Cooling Circuit for GE2/1 Front Chamber Feedback

Stephen D. Butalla

October 1, 2021

Figure 1: Brackets mounted on the longitudinal stiffeners.

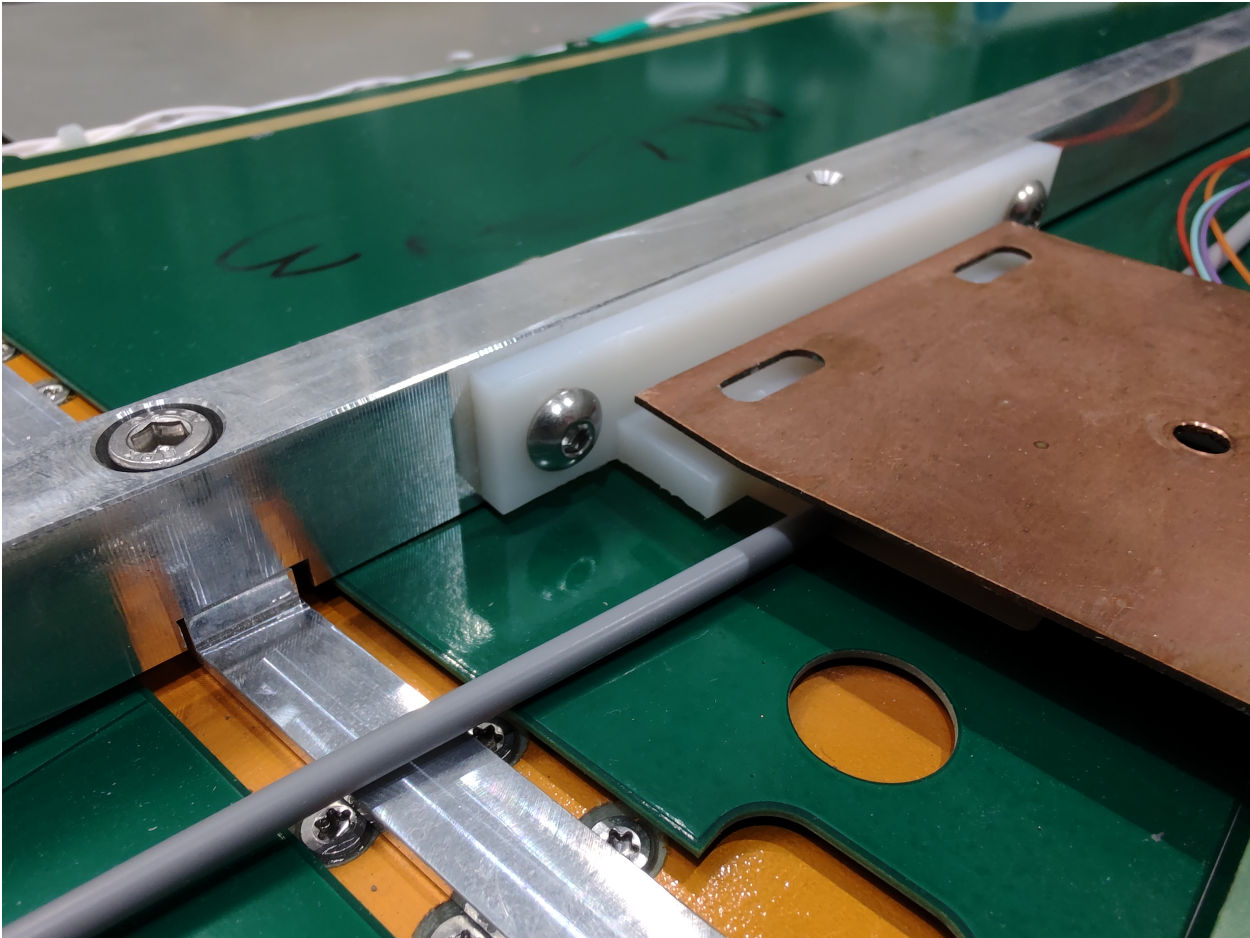
- There are no issues with the mounting brackets fixed to the longitudinal bars; all of the holes are within the tolerances given by the holes on the cooling circuit mount points (see Figs. 1 and 2).

- Through holes drilled in the longitudinal stiffeners according to schematics (Fig. 1).
- Through holes drilled and tapped in the M5 and M8 crossbars (manually located); see Fig. 8.
- Elongated/enlarged holes on the copper plates for the FEASTs (see Fig. 9).
- Resoldered the cooling plate for the 2V5 FEAST on the M6 module (see Fig. 10).

Figure 3: Example of good alignment for the FEAST cooling copper plates on one module.

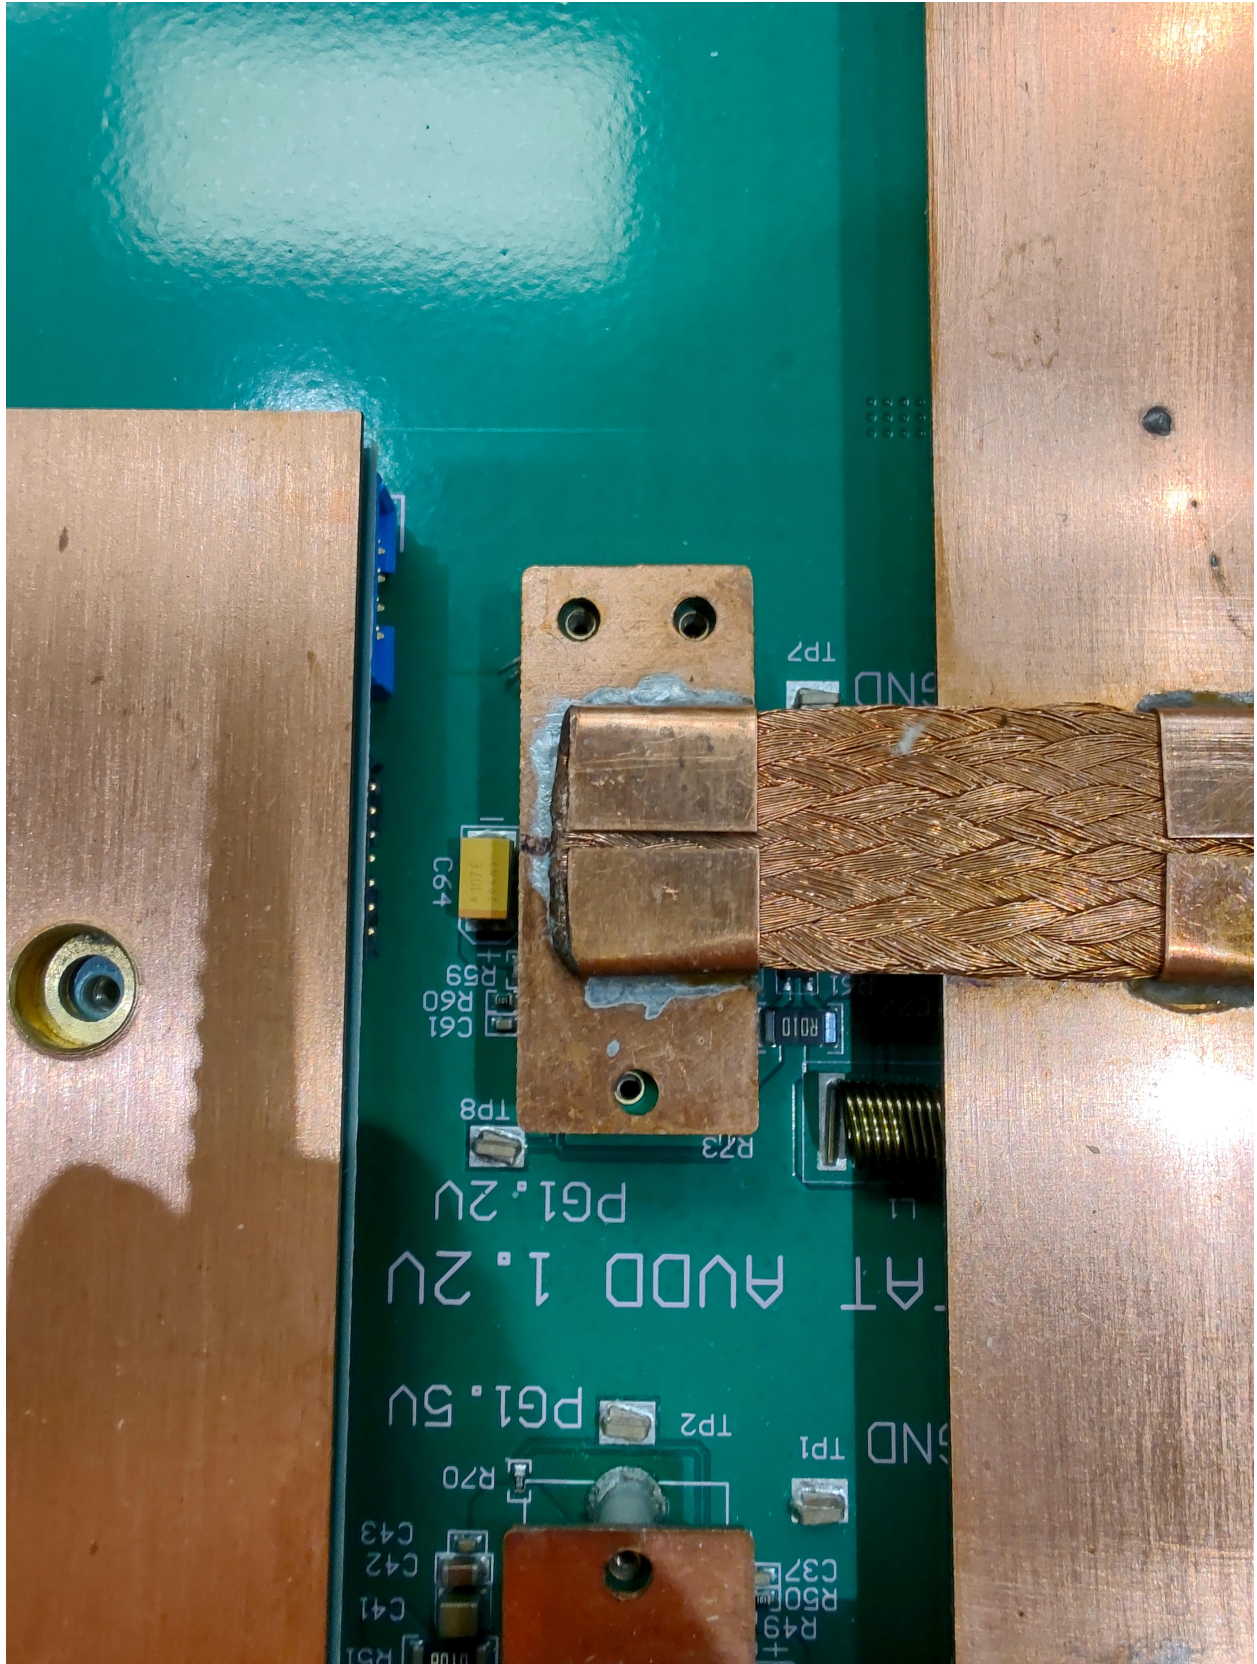
- There are some problems with aligning the copper plates with the FEASTs. E.g., once the copper plates for all FEASTs on one GE2/1 module are aligned (Fig. 3), all of the other copper plates for the FEASTs on other modules are misaligned (see Fig. 4).

Figure 5: The copper cooling plate for the 2V5 FEAST on the M6 module.

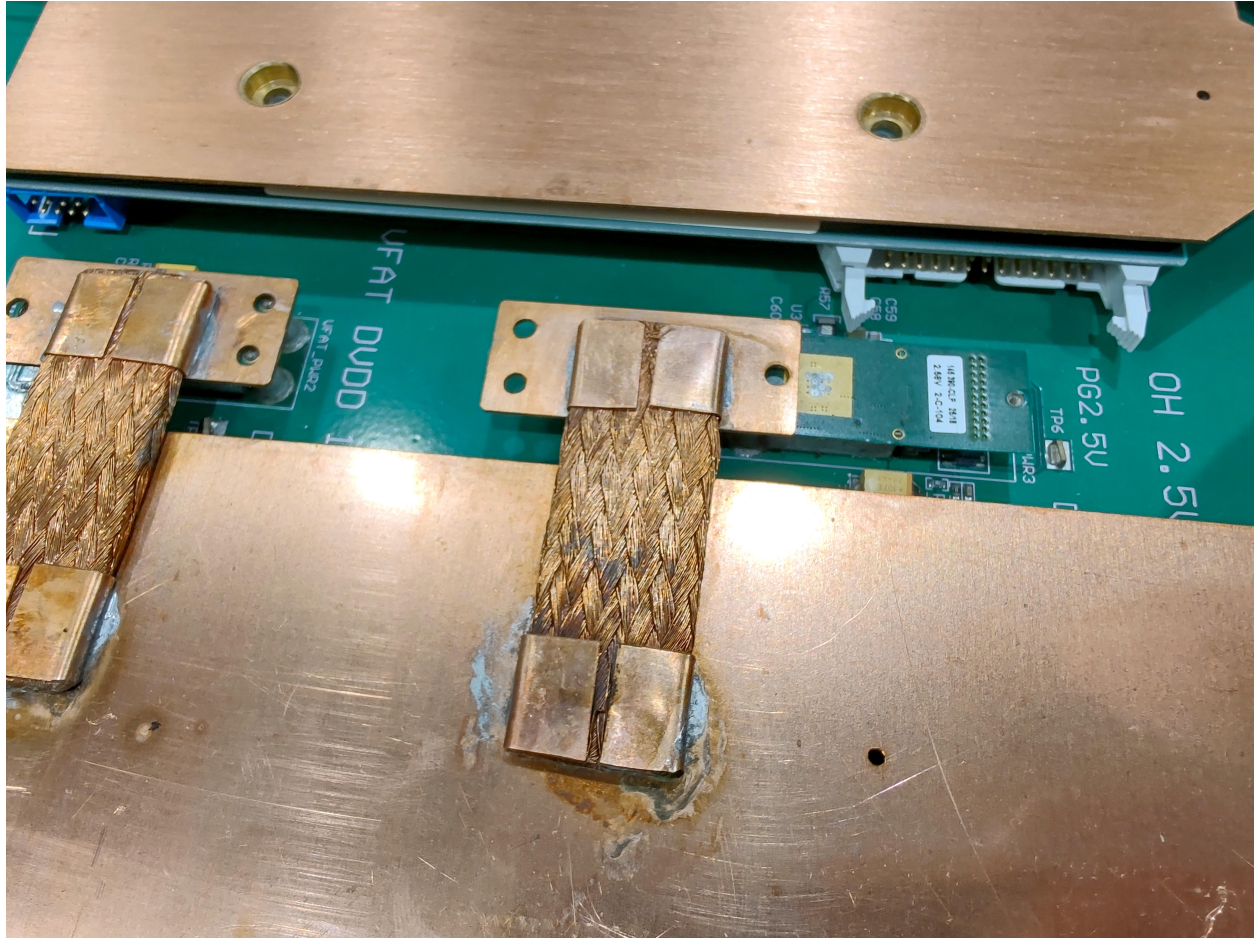
- The 2V5 FEAST on the M6 module is not aligned at all (see Fig. 5).
- Overall, the OH copper plates are well aligned with the OHs (see Fig. 6).
- Good alignment for the VTRx/VTTx cooling plate attached to OH (Fig. 7).
